SECTION 00920

ADDENDUM NO. 2  
CONTRACT 170-18-103  
WATER TREATMENT PLANT  
STANDBY POWER  
RICHMOND UTILITIES BOARD  
RICHMOND, KENTUCKY

April 13, 2018

(EXCERPT FROM SHEET S-3)

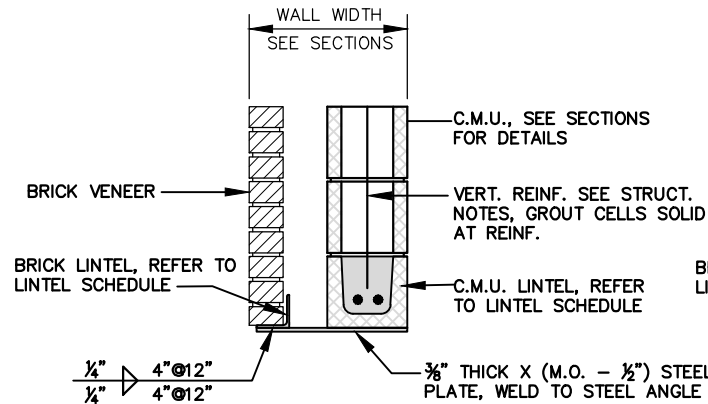
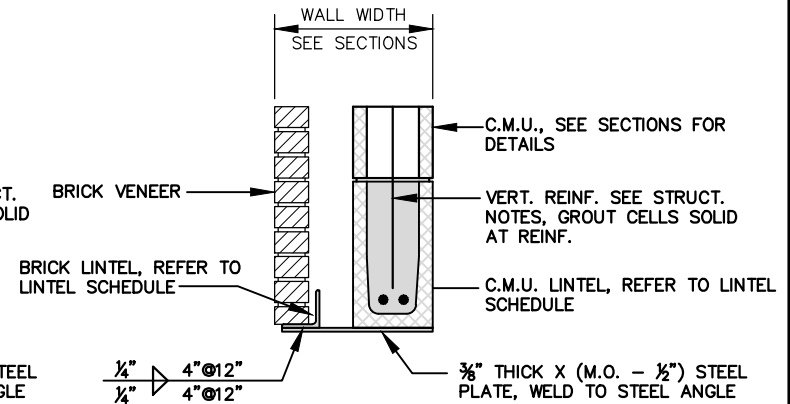
**1. Drawing Sheet S-3 – Structural Sections and Details**

In the bottom right corner of the sheet above the lintel details the tables which are unreadable are being included here as Attachment No. 2.
